**MANDATORY  
SERVICE BULLETIN**

Service Bulletin No. 539A  
(Supersedes Service Bulletin No. 539 and Supplement No. 1)  
Engineering Aspects are  
FAA Approved

SUBJECT: Reprint of Crane/Lear Romec Service Bulletins No. RG9080-73-001, No. RG9570-73-001, and No. RG17980-73-001.

FUEL PUMP-Replacement of valve housing and related seals.

Regulator Valve Assembly Before Modification  
Figure 1

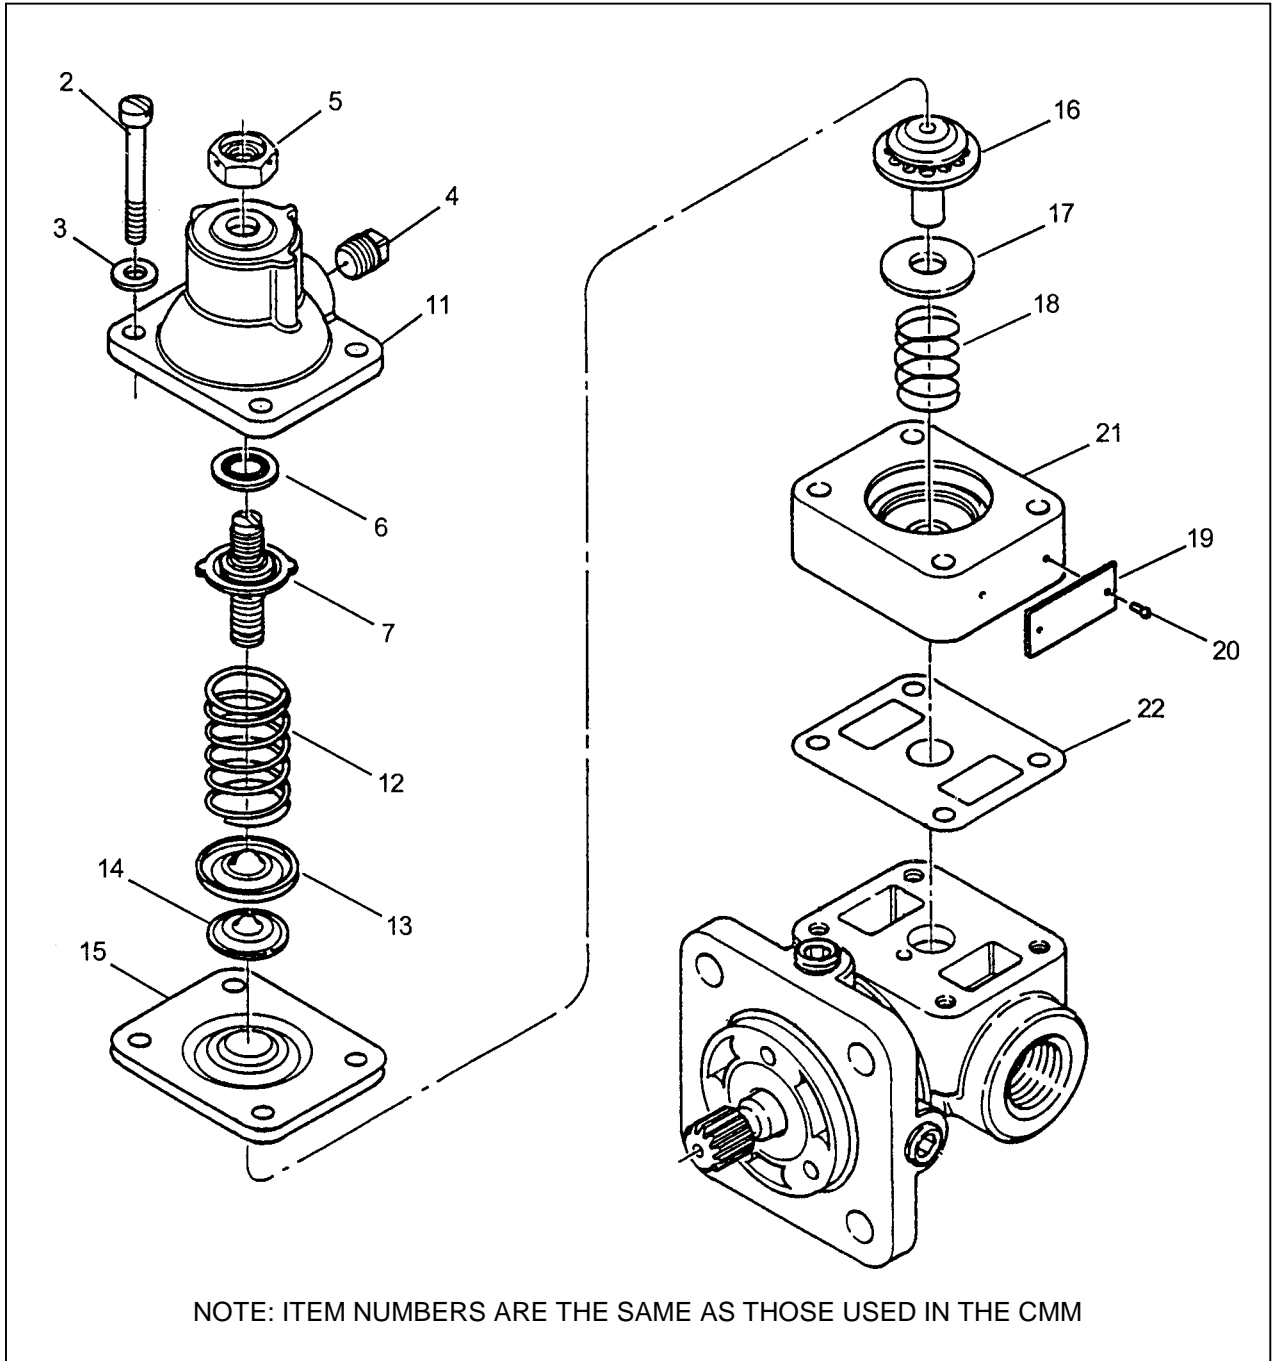
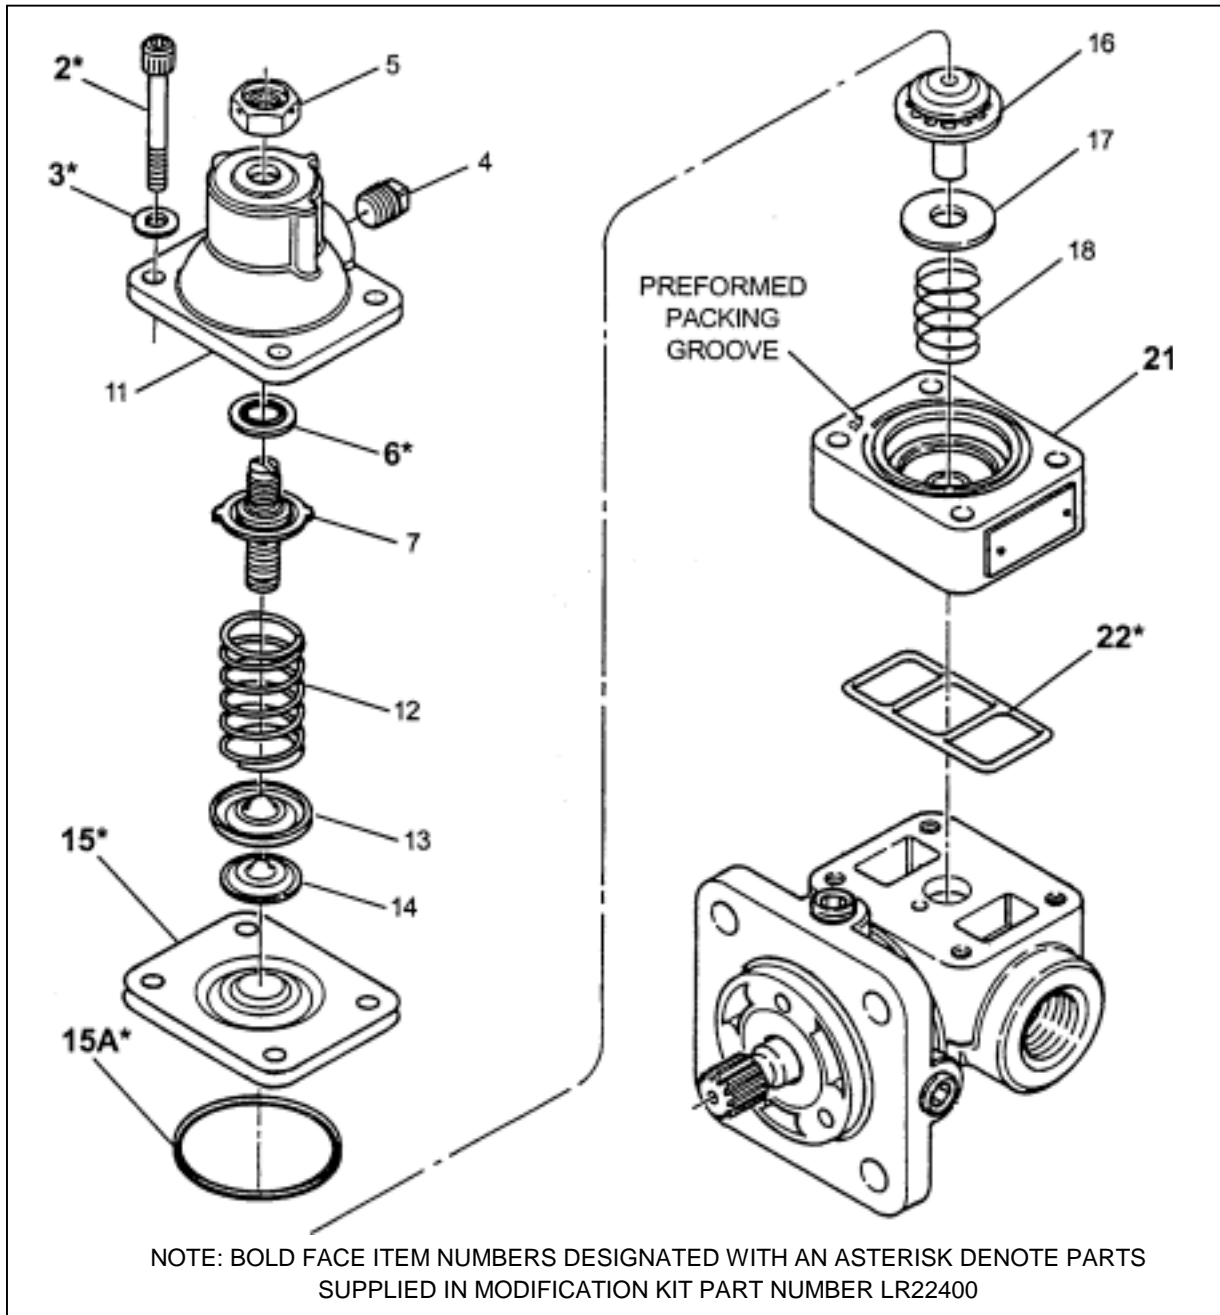
- (1) Cut and remove all safety wire from fasteners,
- (2) Remove screws and washers (items 2 and 3, figure 1 ).
- (3) Separate the regulator valve components (items 4 thru 22) as shown in figure 1.

- (a) Four (4) each screws (item 2, figure 1).
- (b) Four (4) each washers (item 3, figure 1 ).
- (c) One (1) each gasket (item 22, figure 1 ).
- (d) One (1) each valve housing assembly (consisting of parts items 19 thru 21 .figure 1).
- (e) Two (2) each diaphragms (item 15, figure 1 ).

(5) Remove nut (item 5, figure 1) and withdraw the adjusting screw assembly (item 7, figure 1) from the valve cover (item 11, figure 1 ). Remove and discard packing with retainer (item 6, figure 1 ).

- (1) Lubricate the packing (o-ring) portion of the packing with retainer (item 6, figure 2) with petrolatum (petroleum jelly) and install it over the screw slot end of the adjusting screw assembly (item 7, figure 2) and up against the screw flange. Exercise care that screw threads do not nick or cut the packing (o-ring).
- (2) Insert the adjusting screw assembly (item 7, figure 2) through the valve cover (item 11, figure 2) and thread on the locknut (item 5, figure 2). Valve adjustment will be made at test.
- (3) Lubricate the ladder seal (item 22, figure 2) with petrolatum (petroleum jelly) and install it in the groove cut in the surface of the valve housing (item 21, figure 2) that mates with the pump housing.

- (4) Lubricate preformed packing (o-ring) (item 15A, figure 2) with petrolatum (petroleum jelly) and install it in the groove cut into the top of the valve housing assembly (item 21, figure 2).
- (5) Complete assembly according to the applicable component maintenance manual and secure the valve housing (item 11, figure 2) using screws (item 2, figure 2) and washers (item 3, figure 2). Tighten screws evenly and progressively in a crisscross pattern to 23-25 inch-pounds torque in the sequence shown in figure 3.

Torquing Sequence- RG9080 Series  
Figure 3

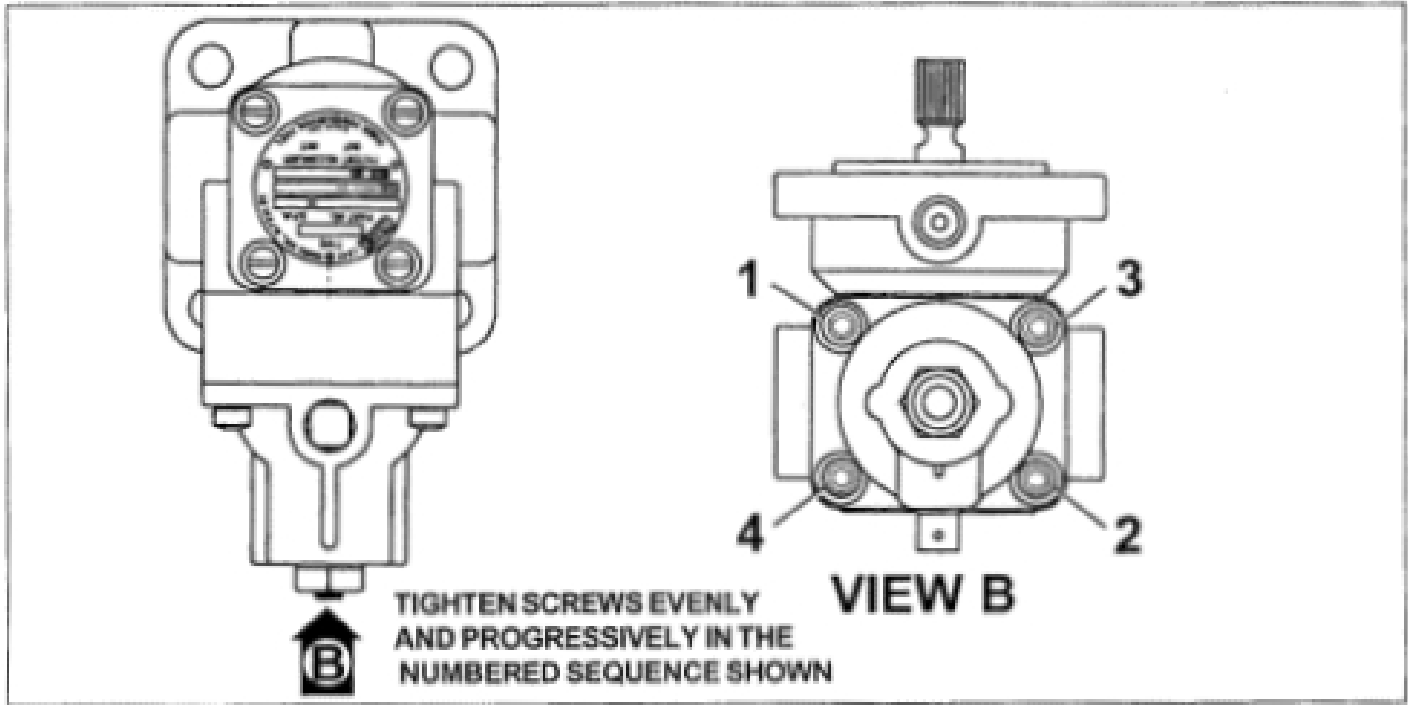
**CAUTION: SEAT THE COVER BY DRAWING DOWN THE SCREWS IN GRADUAL INCREMENTS, FOLLOWING A PROGRESSIVE CRISSCROSS PATTERN AS ILLUSTRATED IN FIGURE 3, UNTIL THE COVER IS FIRMLY SEATED. DRAW DOWN THE SCREWS EVENLY. DO NOT TIGHTEN SCREWS TO FINAL TORQUE DURING THE FIRST DRAW DOWN; UNEVEN TENSION CAN CAUSE DISTORTION OR OVERSTRESSING OF PARTS. COMPLETE THE PROCEDURE BY TIGHTENING EACH SCREW GRADUALLY TO THE SPECIFIED TORQUE VALUE. DO NOT EXCEED THE MAXIMUM TORQUE SPECIFIED.**

Regulator Valve Assembly Before Modification  
Figure 1

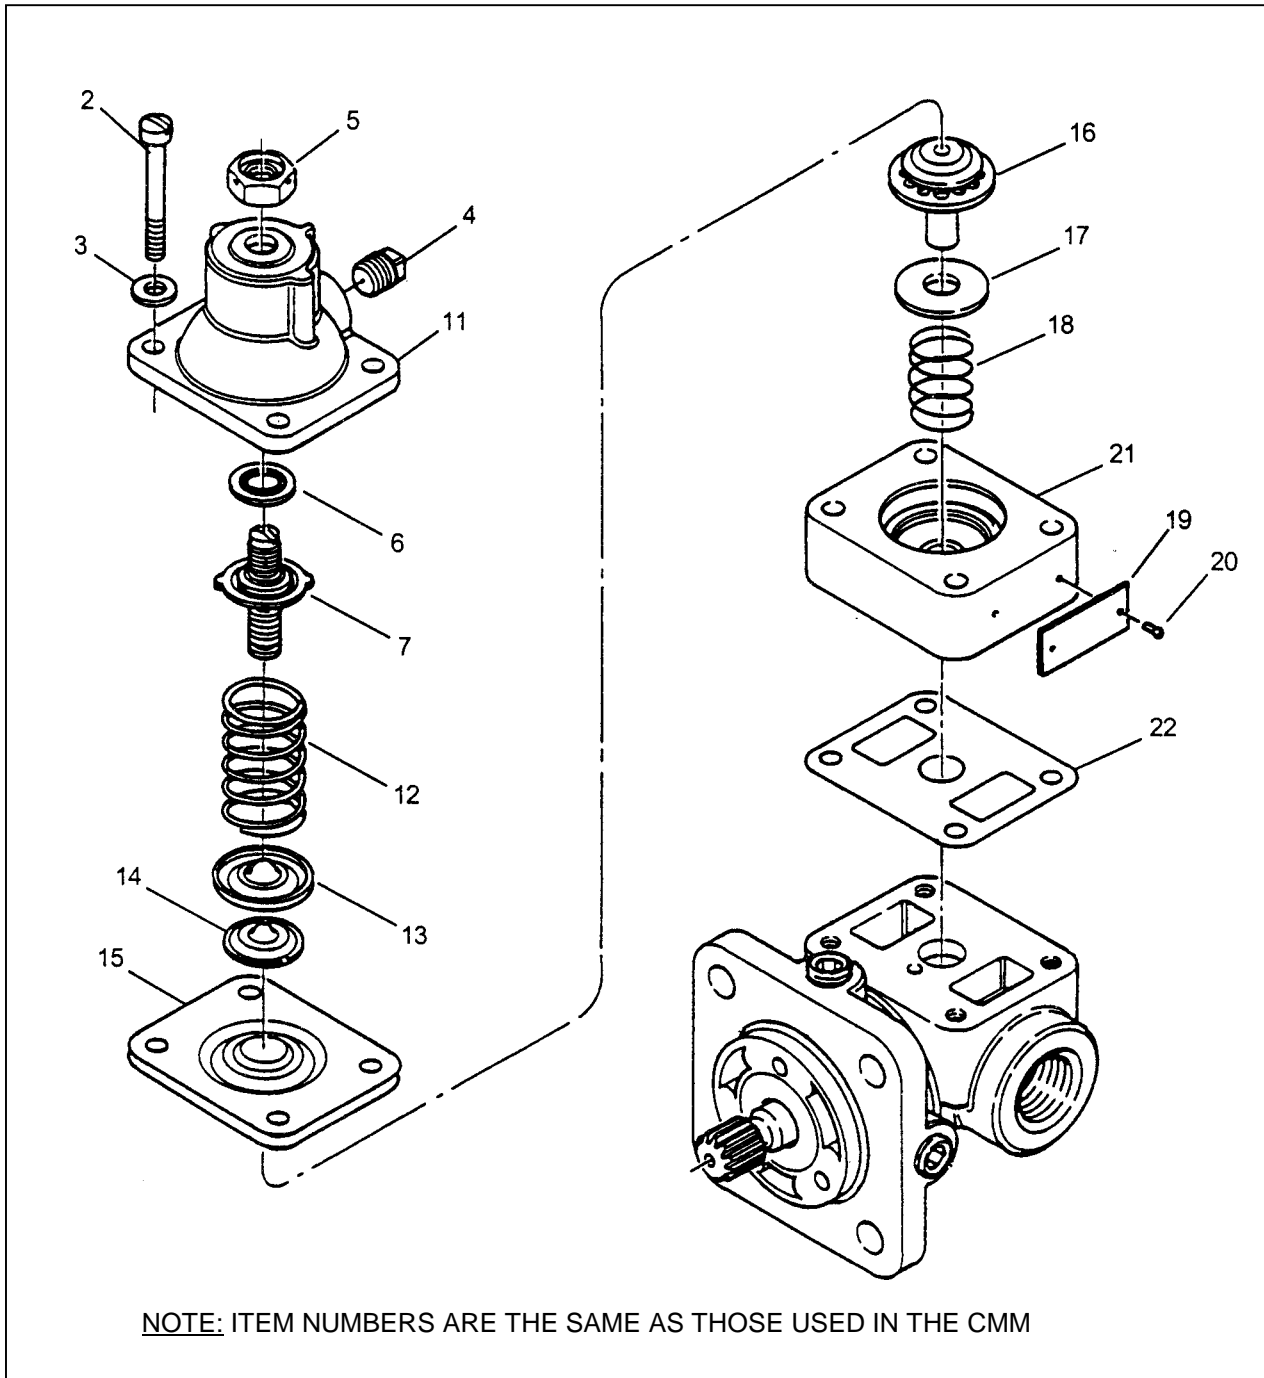
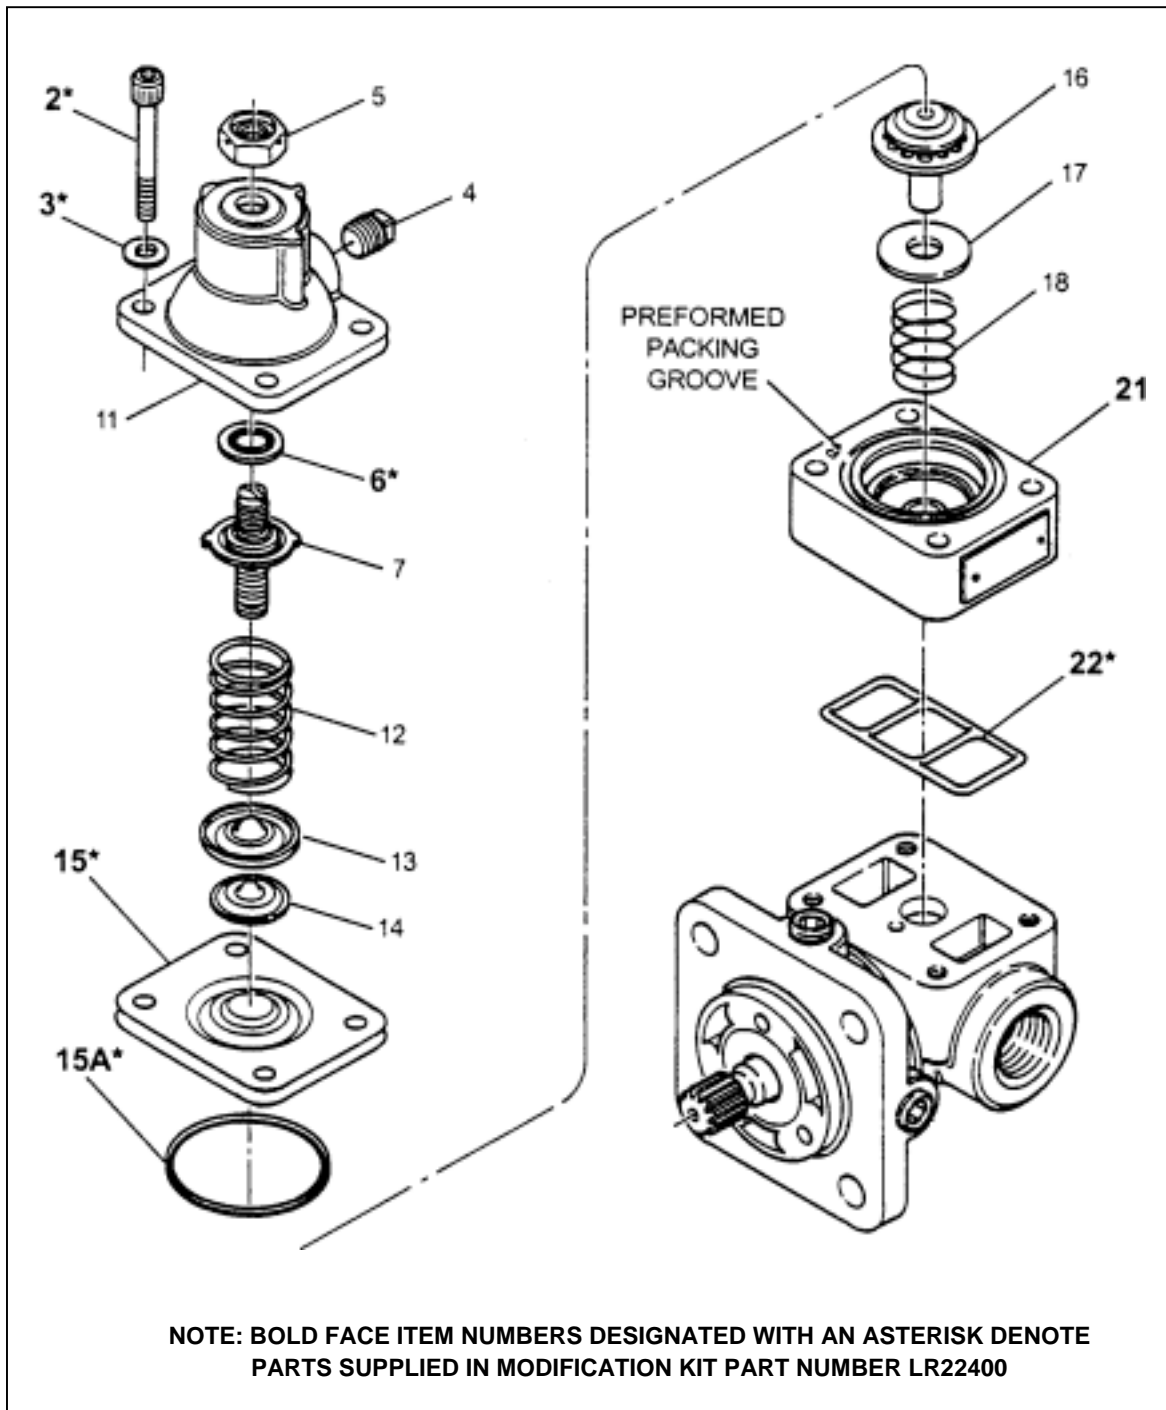
- (1) Cut and remove all safety wire from fasteners.
- (2) Remove screws and washers (items 2 and 3, figure 1 ).
- (3) Separate the regulator valve components (items 4 thru 22) as shown in figure 1.
- (4) Discard the following parts:
  - (a) Four (4) each screws (item 2, figure 1 ).
  - (b) Four (4) each washers (item 3, figure 1 ).
  - (c) One (1 ) each gasket (item 22, figure 1 ).
  - (d) One (1 ) each valve housing assembly (consisting of parts items 19 thru 21, figure 1 ).
  - (e) Two (2) each diaphragms (item 15, figure 1 ).
- (5) Remove nut (item 5, figure 1 ) and withdraw the adjusting screw assembly (item 7, figure 1 ) from the valve cover (item 11, figure 1 ). Remove and discard packing with retainer (item 6, figure 1 ).

- (1 ) Lubricate the packing (o-ring) portion of the packing with retainer (item 6, figure 2) with petrolatum (petroleum jelly) and install it over the screw slot end of the adjusting screw assembly (item 7, figure 2) and up against the screw flange. Exercise care that screw threads do not nick or cut the packing (o-ring).
- (2) Insert the adjusting screw assembly (item 7, figure 2) through the valve cover (item 11, figure 2) and thread on the locknut (item 5, figure 2). Valve adjustment will be made at test.
- (3) Lubricate the ladder seal (item 22, figure 2) with petrolatum (petroleum jelly) and install it in the groove cut in the surface of the valve housing (item 21, figure 2) that mates with the pump housing.

- (4) Lubricate preformed packing (o-ring) (item 15A, figure 2) with petrolatum (petroleum jelly) and install it in the groove cut into the top of the valve housing assembly (item 21, figure 2).
- (5) Complete assembly according to the applicable component maintenance manual and secure the valve housing (item 11, figure 2) using screws (item 2, figure 2) and washers (item 3, figure 2). Tighten screws evenly and progressively in a crisscross pattern to 23-25 inch-pounds torque in the sequence shown in figure 3.

Torquing Sequence-RG9570 Series  
Figure 3

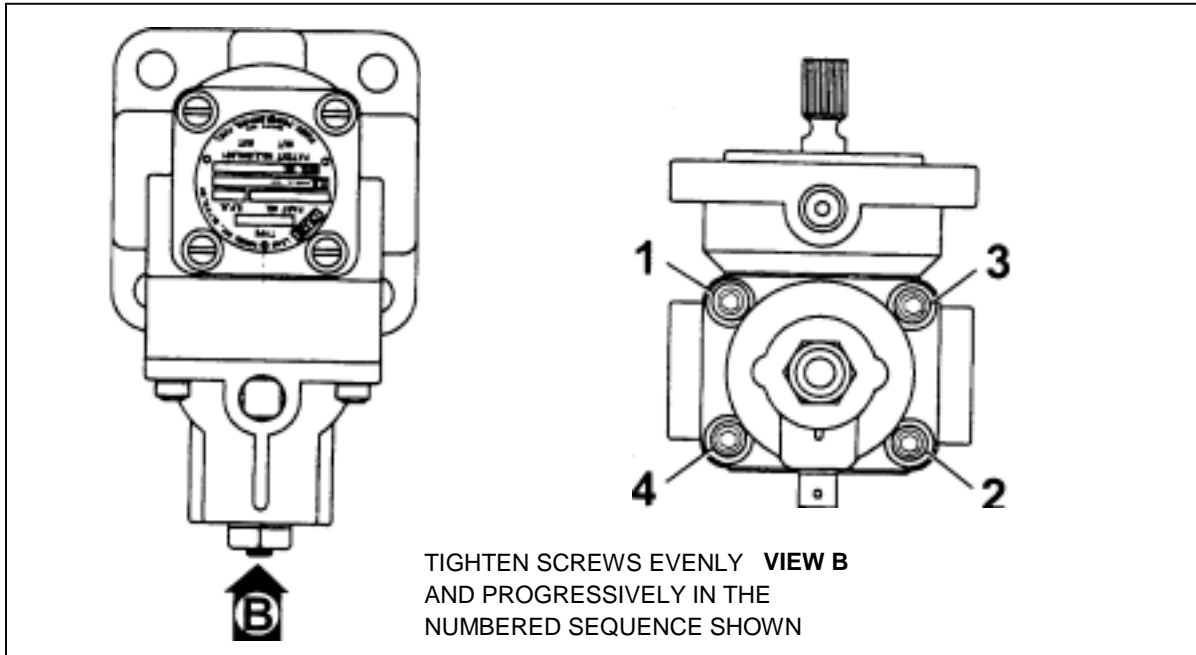
**CAUTION: SEAT THE COVER BY DRAWING DOWN THE SCREWS IN GRADUAL INCREMENTS, FOLLOWING A PROGRESSIVE CRISSCROSS PATTERN AS ILLUSTRATED IN FIGURE 3, UNTIL THE COVER IS FIRMLY SEATED. DRAW DOWN THE SCREWS EVENLY. DO NOT TIGHTEN SCREWS TO FINAL TORQUE DURING THE FIRST DRAW DOWN; UNEVEN TENSION CAN CAUSE DISTORTION OR OVERSTRESSING OF PARTS. COMPLETE THE PROCEDURE BY TIGHTENING EACH SCREW GRADUALLY TO THE SPECIFIED TORQUE VALUE. DO NOT EXCEED THE MAXIMUM TORQUE SPECIFIED.**
